**REQUEST**

Approximately 8.025 acres located on the west side of Sharon Road, west of the intersection of Sharon View Road (Council District 6 - Bokhari)

The petition proposes redevelopment of a portion of the Sharon Towers campus to allow independent living and a mixture of uses to serve the residents and general public.

**PLANNING STAFF REVIEW**

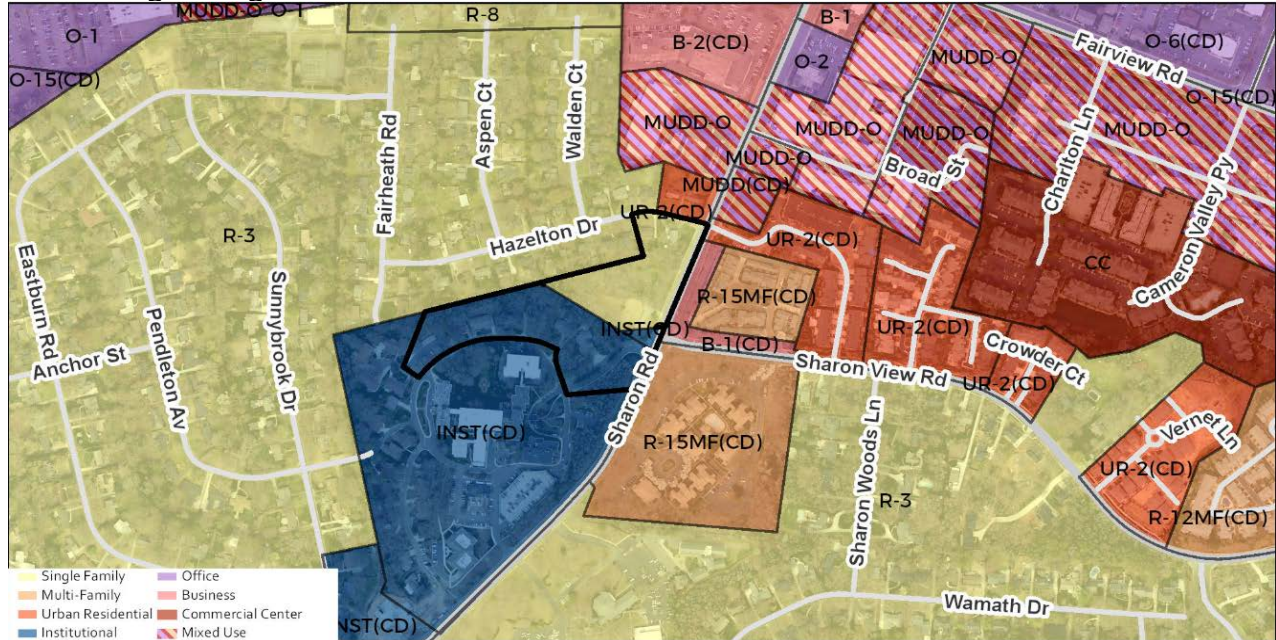
5. ~~Label the possible retaining wall on the conceptual site section sheet RZ-7A and 7B.~~ *Addressed.*
6. ~~Amend the development standards to provide a development area summary table that is legible.~~ *Addressed.*
7. ~~Amend the development area summary table heading for maximum height at setback to read "Maximum height at Building side yard/ separation from common boundary" to avoid confusion with the 68.75 separation for Area D.~~ *Addressed.*
8. ~~Amend the development summary table and any related conditional notes to change references to "setback" along the northern property line to "side yard/separation" to provide consistency in language.~~ *Addressed.*
